# Staff Report and Recommendations Agenda of June 24, 2024, Item 6a

## County of Ventura • Resource Management Agency

A request for a Certificate of Appropriateness from the Cultural Heritage Board (CHB) (Ventura County Cultural Heritage Ordinance Section 1371) for a two-story addition of 1,120 square feet to an existing one-story, single-family residence located at 152 G Street, Oxnard, CA 93030 (Henry T. Oxnard Historic District and Landmark Area #161) (Case No. CH24-0025).

Figure 2 – Proposed Profile

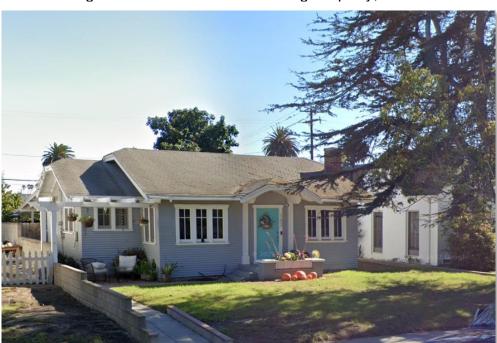
Standards	Staff Comments
	preserving the historic character of a historic property. <sup>6</sup>
	The existing main residence is an American Colonial Revival bungalow of approximately 15 feet in height. The proposed addition would substantially increase the amount of habitable square footage and increase the maximum height of the structure to approximately 25 feet. Based on this, the views of the main residence from the public right of way are proposed to change substantially. It should be noted that a few residences in the vicinity of the subject property presently contain two-story, rear additions.
	The exterior of the addition would be in keeping with the architectural style of the main residence. However, the design of the proposed addition would follow and enlarge the existing massing of the residence, and enlarge and extend the northern and southern wall planes, risking unification of the two volumes into a single architectural whole. Moreover, the existing residence would be substantially insubordinate to the proposed addition.

Standards	Staff Comments
	Based on these considerations, the proposed addition appears inconsistent with this Standard.
#10. New additions and adjacent or related new construction will be undertaken in such a manner that, if removed in the future, the essential form and integrity of the historic property and its environment would be unimpaired.	The design of the proposed addition extends the wall plane of the existing building and risks unification of the two volumes into a single architectural whole. Such a design may preclude the ability to remove the addition in the future while maintaining the essential form of the residence as the identity of the historic structure may be lost in a new and larger composition.
	Based on these considerations, the proposed addition appears inconsistent with this Standard.

Based on the above considerations, the proposed scope of work appears partially inconsistent with the Secretary's Standards. Following implementation of the project, the residence would retain distinctive features of its American Colonial Revival bungalow style. However, of notable exception, the proposed addition risks unification of the two volumes into a single architectural whole. Moreover, the main residence would be substantially insubordinate to the proposed addition.

Recommendation #1: Rear Addition. The proposed design should separate
the addition from the historic building by offsetting the addition or stepping it
back from the mass of the historic building, or minimizing visual impacts
through other similar means. With implementation of this recommendation, the
addition should be clearly differentiated and distinguishable as a new addition
